UNITED STATES  
NUCLEAR REGULATORY COMMISSION  
WASHINGTON, D.C. 20555

TOPICAL REPORT REVIEW STATUS SUMMARY  
SOLIDIFIED WASTE FORMS AND HIGH INTEGRITY CONTAINERS (HIC's)

TECHNICAL EVALUATION REPORT

related to the Topical Reports on  
High Integrity Containers made with  
High-Density Polyethylene

Figure 1. Critical vertical and lateral loads for creep buckling  
(Figure taken from Silling Report (Ref. 32) )

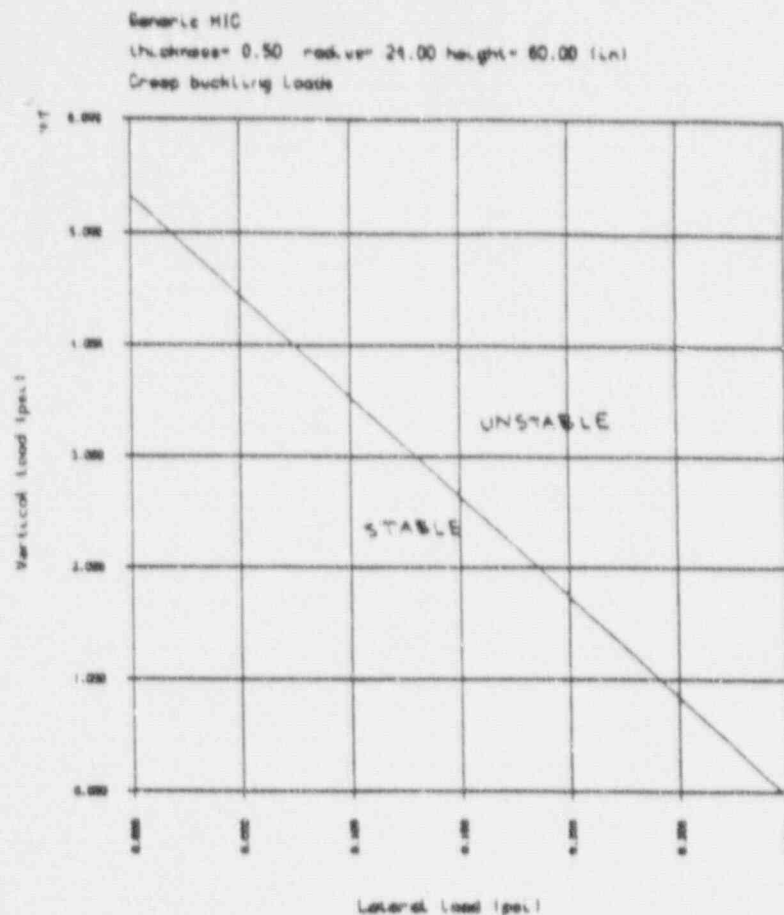
The simple buckling analysis that is included in the Silling Report uses the methods of Timoshenko and Gere (Ref. 43), adjusted to include the Secant Modulus described above. It also accounts for both axial compression loads and lateral loads, which is different from the HDPE HIC vendors' analyses, which only account for axial compression loads imparted by burial overburden. The Silling Report included results from a computer analysis of the generic HDPE HIC, reproduced here as Figure 1. Any combination of vertical and lateral loads above and to the right of the line indicates an unstable buckling condition. As can be seen, the lateral loads cause the most problem in making the HDPE HIC unstable. The Silling Report explains that buckling of the HIC could to an extent be inhibited by the soil surrounding the HIC. The Report details experiments conducted to quantify this support, and using one of the models in the literature, concludes that even under the most favorable conditions of support from surrounding soil, buckling would still occur.

The Silling Report also explains that buckling would be resisted to some extent by the waste inside the HDPE HIC. The Report, however, notes that none of the vendors has characterized the mechanical properties of the waste, and that, even if the waste were properly characterized, operational procedures would be necessary to ensure that all HICs were filled with waste that had the identical properties that were analyzed. The Silling Report points out that if the waste acts like a fluid or a low-friction granular solid, the waste would provide very little, if any, structural support.

supporting the loads upon burial. The Silling Report also concludes that such support is likely. However, the contribution of the waste in analysis must be supported by characterization of the waste, especially in terms of the change in material properties (e.g. the breakdown of organic resins) of the waste with time considering the long time (300 years) that the support must be present. The Silling Report also argues that it would be unlikely that a system could be implemented that would result in assurances that waste with the necessary properties would go into the HDPE HICs every time one is filled. The vendors have not submitted evidence that quantifies the contribution of the waste in analysis for buckling. The NRC staff concludes that the data and information presented indicates that vertical and lateral loads from the soil contribute to buckling of HDPE HICs. The NRC staff also concludes that it is difficult to include creep in buckling analysis of HDPE HICs and that there are large uncertainties about the contribution of waste materials in supporting the burial loads experienced by HDPE HICs. The NRC staff concludes that buckled HICs are virtually impossible to analyze using accepted structural mechanics methods; Buckling, thus, presents a major unresolved concern regarding the HDPE HICs ability to meet the 300-year structural stability requirement of 10 CFR Part 61.

Figure 2. Time to failure of unirradiated HDPE (data of Graube)  
(Figure taken from Silling Report (Ref. 32) )

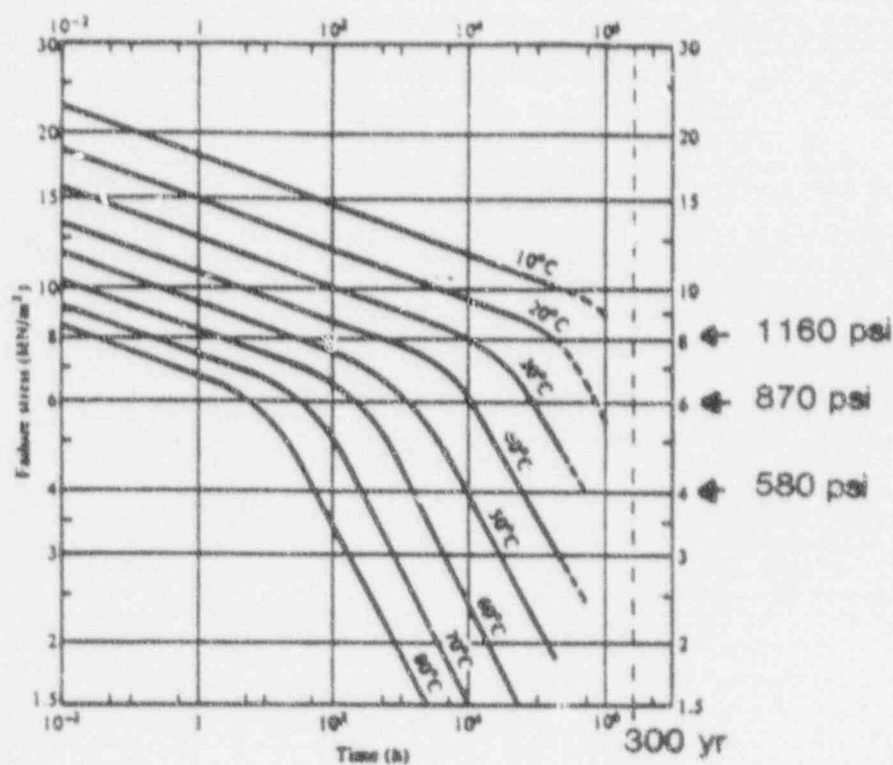
The Silling Report (Ref. 32) describes problems with the degradation of the mechanical properties of high-density polyethylene that were reported in the literature. Silling describes published results of tests performed by Graube on pressurized pipes manufactured by the extrusion process with Hostalen GM 5010, which is a linear HDPE of moderately high molecular weight. Figure 2 shows the data of Graube, as reported in the Silling Report. The horizontal axis is time and the vertical axis is stress. The curves are drawn at stresses

where failures occurred in the pressurized pipes for the given temperatures. The distinct bends in the curves indicate a transition from ductile failure to brittle failure (ductile failure means that extensive deformation of the material will occur prior to rupture, while a brittle material fails without extensive deformation). At room temperature (20°C), the Graube data indicate that this ductile/brittle transition would take place at approximately 11 years. From the graph, it can be seen that failure will occur at much lower stresses as time goes on after this ductile/brittle transition takes place. The Silling Report points out that the material in the Graube tests was different than Marlex CL-100, and points out that there is evidence that a controlled amount of cross-linking tends to reduce the susceptibility of HDPE to brittle failure. However, the Silling Report goes on to say that this reduction in susceptibility is evident mostly at high temperatures, and that,

while the ductile/brittle transition may take place at a later time, the failure is much less sensitive to the stress level once the transition occurs, and thus, failures may occur at very low stress levels.

ductile/brittle transition in HDPE. The NRC staff recognizes that there is great uncertainty regarding whether the embrittlement of the linear HDPE pipes tested by Graube and reported in the Silling Report is indicative of a problem with embrittlement of the cross-linked HDPE that is used to make the HICs. The Silling Report points out this uncertainty and also points out the differences between the two types of HDPE and that it is unknown whether these differences play a part in the performance of the HDPE in regards to a ductile/brittle transition. The Silling Report, however, points out that other data similar to the Graube test results are also available from other studies. The information submitted by CNSI and Hittman that they obtained from the Phillips Chemical Company presents evidence that is intended to show that the ductile/brittle transition behavior of Marlex CL-100 is much different than the linear HDPE of the Graube tests, but further investigations into the limited Phillips information by the NRC staff indicate that the behavior of the Marlex CL-100 HDPE is not dissimilar to the linear HDPE of the Graube tests at extended time periods. The NRC staff concludes that the data presented indicate that embrittlement of Marlex CL-100 HDPE at low stress levels can be a problem and that embrittlement presents a major and unresolved concern regarding the HDPE HICs ability to meet the 300-year structural stability requirement of 10 CFR Part 61.

Figure 3. Stress to rupture data of Marlex CL-100 drawn by CNSI  
(Figure taken from Ref. 37)

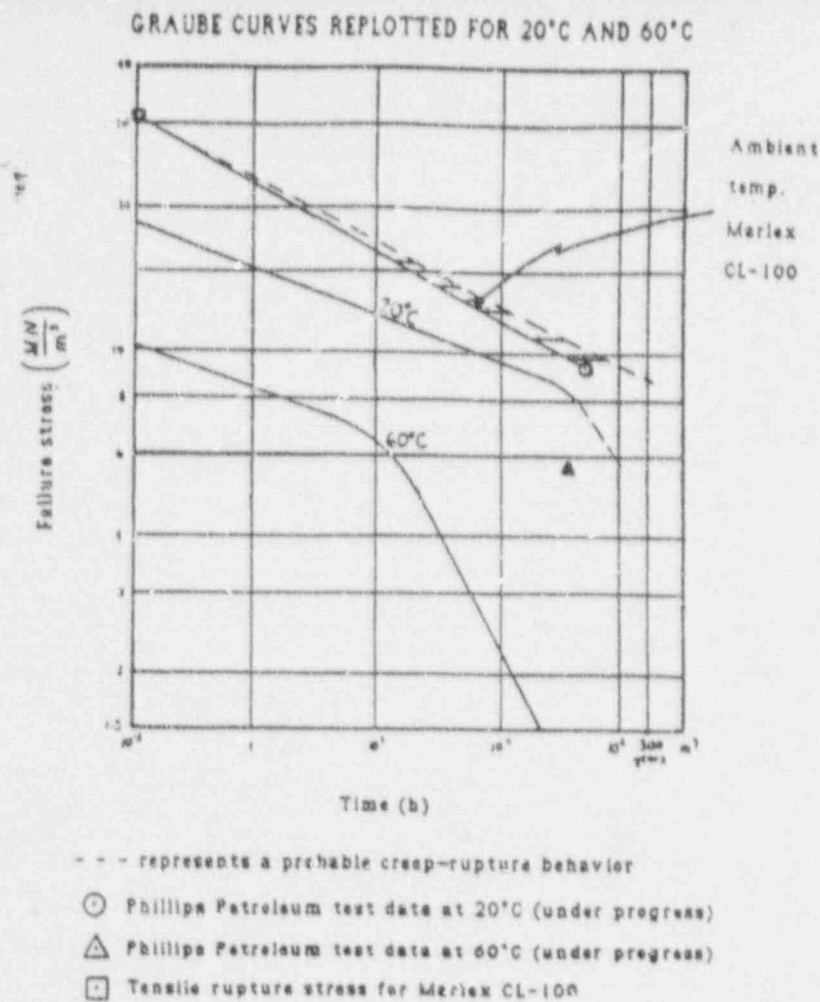
CNSI argues two points about the information in the Silling Report in their August 8, 1988 (Ref. 37) submittal to the NRC. CNSI first cites information they obtained from the Phillips Chemical Company, manufacturers of Marlex CL-100, that indicates that CL-100 has improved ductile properties. Figure 3 is a graph submitted to the NRC by CNSI to support their claim. The graph is the Graube data graph redrawn to show just 20°C and 60°C results from Graube, with graphical interpretations of the new Phillips data on Marlex CL-100 drawn on the graph by CNSI. The CNSI graphical interpretations are extrapolations of on-going 20°C and 60°C pipe tests being conducted at certain stress levels by Phillips during which no failures have taken place. The CNSI extrapolated data indicates that the ductile/brittle transition "knee" is at a later time for Marlex CL-100 than the Graube curves, and therefore, this material has better performance regarding this property. The second point that CNSI argues is that the Graube data are not applicable since the uniform axial and circumferential stresses imposed on the pipes during the tests described are both tensile, while burial loads are mostly compressive. CNSI also argues that the data is inapplicable because the Graube tests are uniform loading tests, while the loading in a real burial environment will not be uniform due to stress relaxation.

- 1) The tests were run on sample Marlex CL-100 pipes in order to establish a standard with the Plastics Piping Institute.
- 2) Failures have taken place, as reported in the Hittman submittal.
- 3) After further investigation, Mr. Rees determined that the stresses the pipe tests had been conducted at, which he reported to CNSI and Hittman (who then reported to the NRC) were in error, and that the correct stresses are approximately 200 psi less than had previously been reported.
- 4) The tensile rupture stress value for Marlex CL-100 is between 3000 - 4000 psi, and that the value of 4600 psi used by CNSI in their graph (Figure 3) is high.

Figure 4. Marlex CL-100 curve drawn by NRC staff

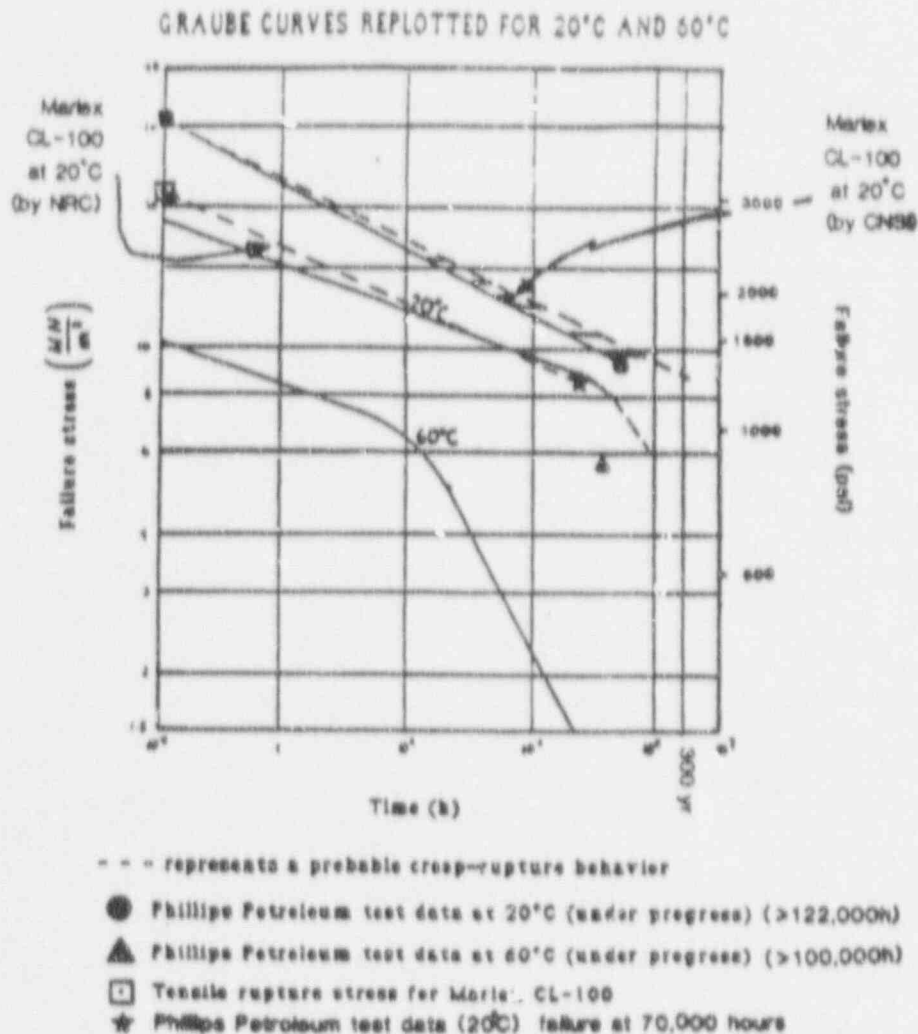
This clarification of the test information allowed the NRC staff to draw its

own interpretation of the Marlex CL-100 pipe test results using the same graph that was submitted by CNSI. Figure 4 is this graph, including the NRC staff interpretation of the Marlex CL-100 test results. The 20°C curve for Marlex CL-100 drawn by NRC staff is nearly the same as the Graube linear HDPE data, indicating that the behavior of the Marlex CL-100 is likely to be very similar to that of the HDPE tested by Graube.
